CONTRACT CHANGE ORDER NO. 258
SHEET 2 OF 3

SAN FRANCISCO OAKLAND BAY BRIDGE
EAST SPAN SEISMIC SAFETY PROJECT
SELF-ANCHORED SUSPENSION BRIDGE
(SUPERSTRUCTURE & TOWER)

WEST DEVIATION SADDLE BIRD SCREEN DETAILS NO. 1

WEST JACKING SADDLE BIRD SCREEN DETAILS NO. 1

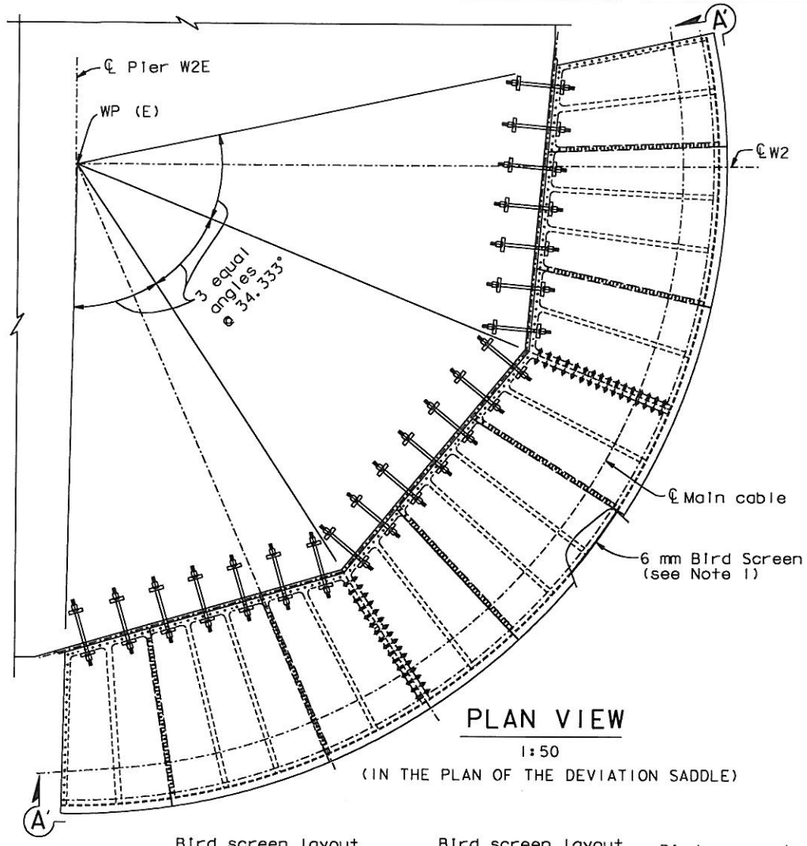
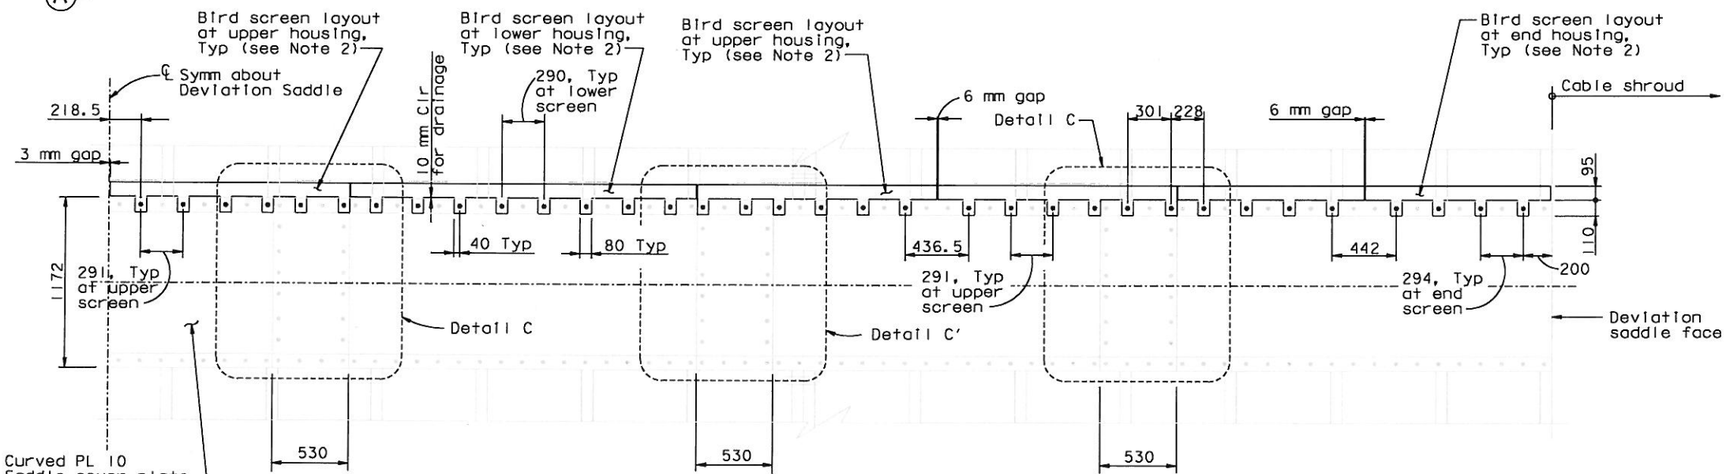
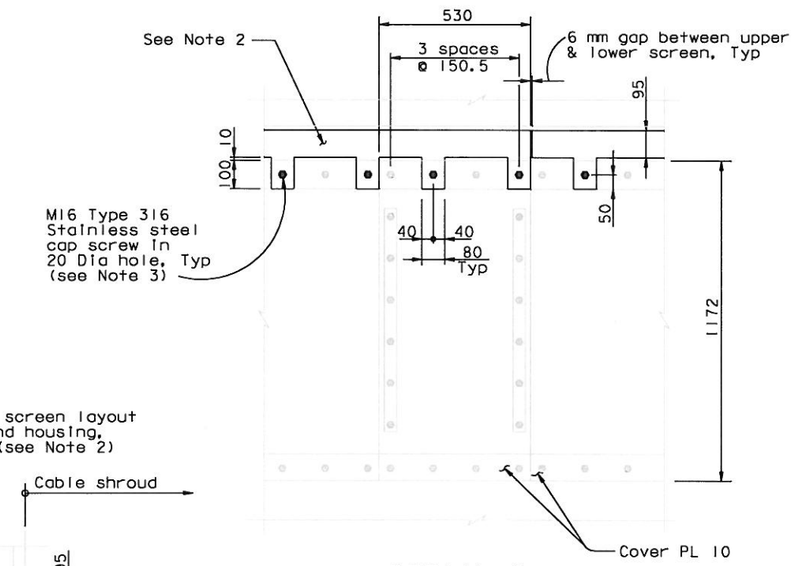
MARK	DATE	DESCRIPTIONS	BY	CH'D	CCO#
0	01/28/13	BIRD BARRIER AT WEST SADDLES	GB	MN	258

1. The bird screen shall be ASTM A36 and painted. The plate shall be bolted to the trough housing plates as detailed. The Contractor shall provide new M16 cap screws to secure the bird screen.
2. Plate lengths and dimensions shall be field verified prior to fabrication.
3. The holes in 6 mm plates shall be standard oversize to allow fit-up. The Contractor shall use oversized washers.
4. At the Contractor's option, 0-6 mm radius may be provided at corners of the bird screen.

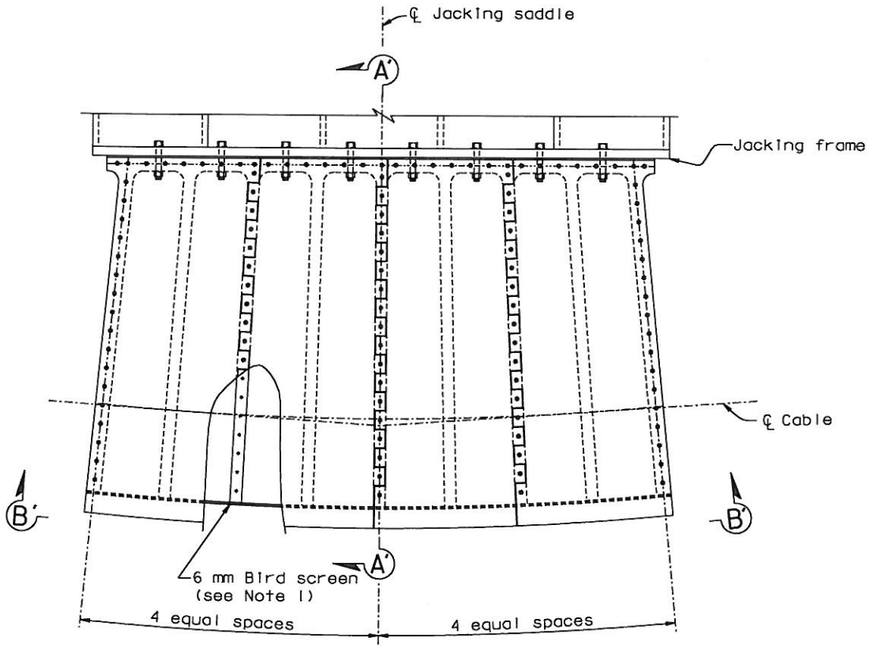
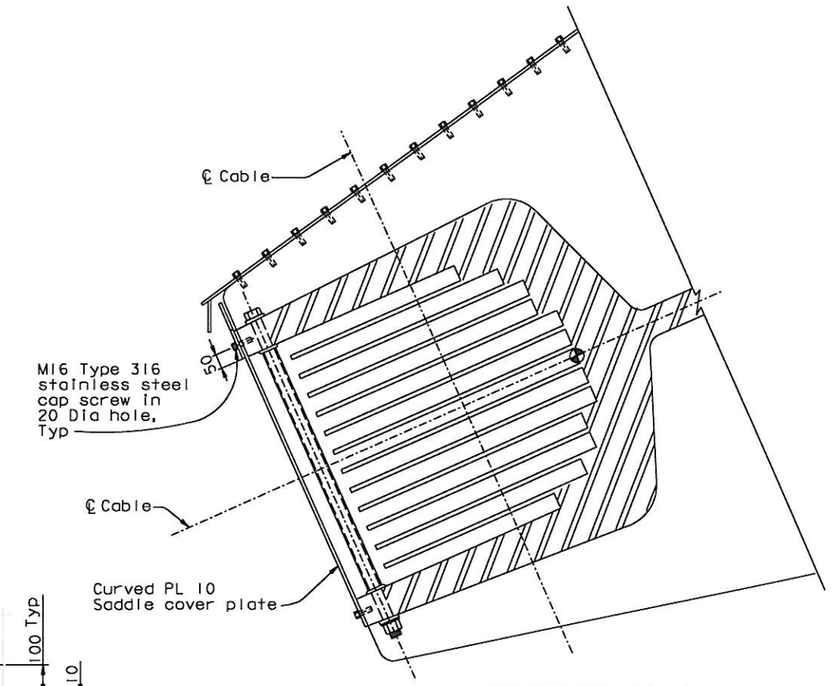
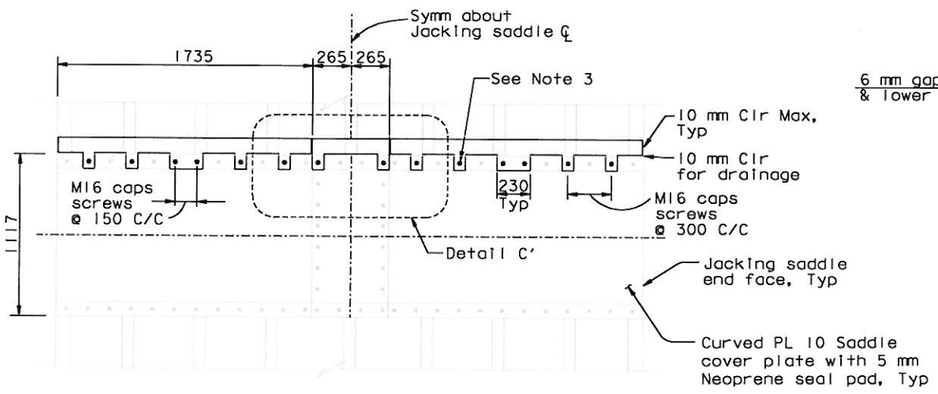
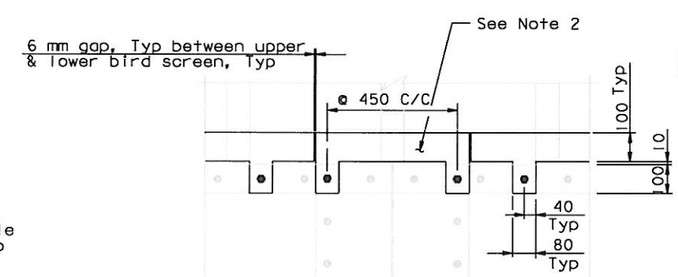
MARK	DATE	DESCRIPTIONS	BY	CH'D	CCO#
0	01/28/13	BIRD BARRIER AT WEST SADDLES	GB	MN	258

1. The bird screen shall be ASTM A36 steel and painted. The plate shall be bolted to the trough housing plates as detailed. The Contractor shall provide new M16 cap screws to secure the bird screen.
2. Plate lengths and dimensions shall be field verified prior to fabrication.
3. The holes in 6 mm plates shall be standard oversize to allow fit-up. The Contractor shall use oversized washers.
4. At the Contractor's option, 0-6 mm radius may be provided at the corners of the bird screen.
